Clarksburg Childcare Center, Preliminary/Final Water Quality Plan, S2850

Preliminary Water Quality Plan: Clarksburg Child Care Center

Preliminary/Final Water Quality Plan for Clarksburg Childcare Center SM File #: 242178 Tract Size/Zone: 1.02 acres/R-200 Watershed: Little Seneca Creek

Figure 2: Proposed Impervious Surface Area Exhibit

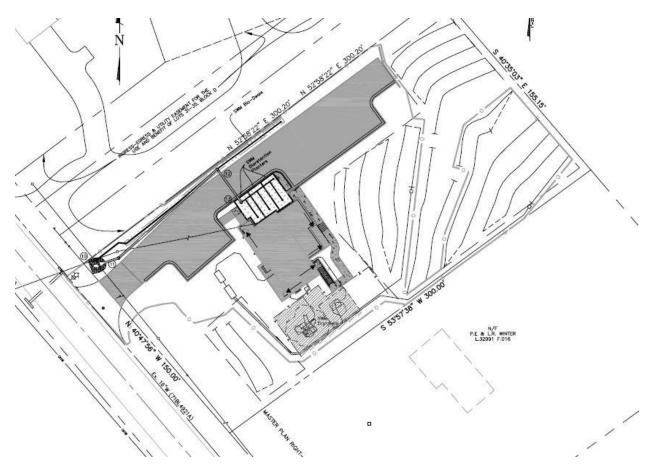
The proposed project proposes a post development condition of 10,300 square feet, or 22.6% impervious surface area on the 45,665 square foot property. (see Attachment B)

The property is zoned R-200. Impervious surface rates across the county for the R-200 zone are generally between 15.4% and 19.0%. There is no imperviousness cap within this portion of the Clarksburg SPA so we use the general county average for the zone as a goal. At 22.6% the proposed

project is slightly higher than the upper goal of 19.0%. The applicant has minimized usage of all impervious surfaces to the greatest extent possible while achieving the goals of the use and meeting all other county regulations (parking and ADA compliance).

Staff finds that the applicant has reduced imperviousness while accommodating the program requirements and meets the impervious requirements of the Clarksburg SPA.
